ESPAR HEATER MODIFICATION INFORMATION BULLETIN

UP 054 REV 1 2010-04-01

AMBULANCE TYPE: MX151D 2009

LE :	ESPAR HEATER ACTIVATION
	MODIFICATION

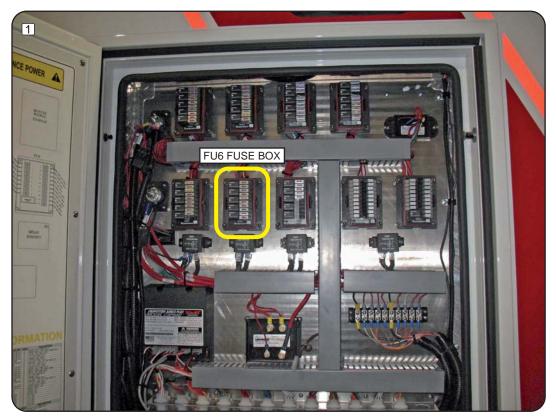
This bulletin is to inform owners of Demers Ambulances that a modification of the Espar heater activation is required as per BCAS request. The Espar heater should only work when the engine is running.

Perform the modification as per the attached documentation. The modification can be performed during any scheduled 'A' Service Safety Inspection.

# DRAWING : REV : 1
00646 PAGE : 1/6

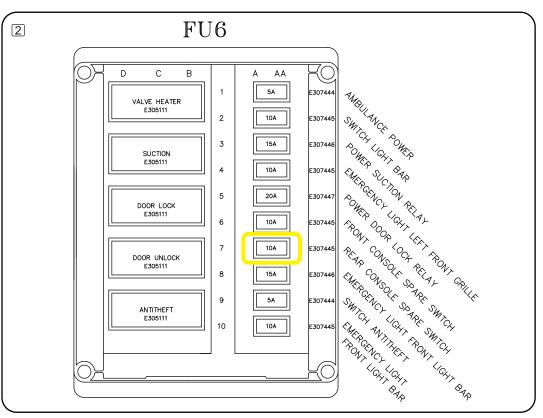
BEFORE PROCESSING MODIFICATION, LOCATE THE FUSE BOX FU6 IN ELECTRICAL PANEL.

LOCATE AND REMOVE THE 10 AMP FUSE IN POSITION 7 OF THE FU6 FUSE BOX.

DRAWING : REV : 1

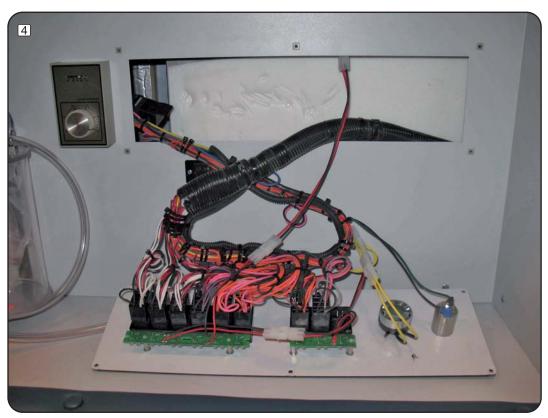
TO REMOVE THE CONSOLE PANEL, LOCATE AND UNSCREW THE SIX (6) SCREWS AS SHOWN.

REMOVE THE REAR CONSOLE TO HAVE ACCESS TO THE HEATER SWITCH AND RELAY.

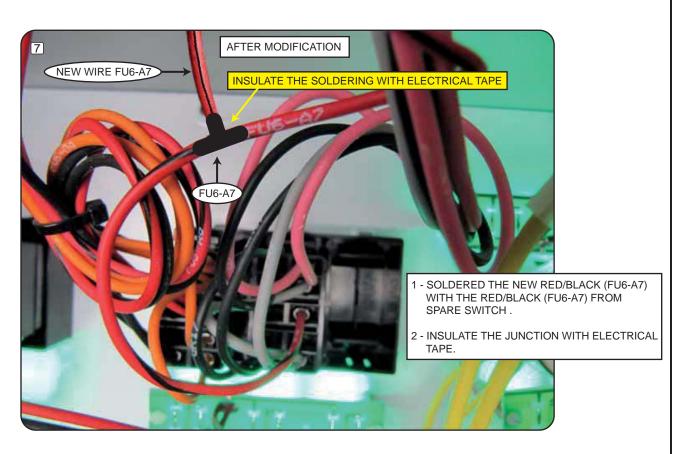
LOCATE THE RED-BLACK WIRE (FU6-A7) FROM THE SPARE SWITCH.

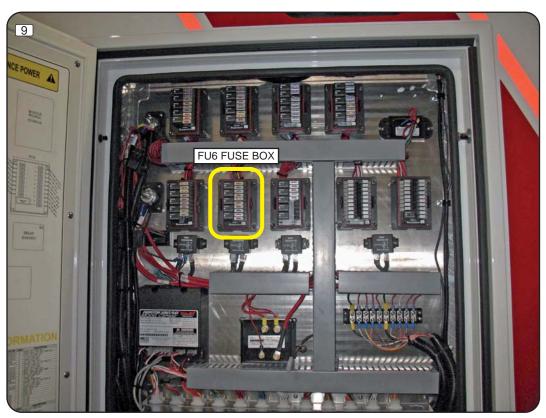
REINSTALL THE CONSOLE PANEL.

REINSTALL THE 10 AMP FUSE IN THE FU6 FUSE BOX.
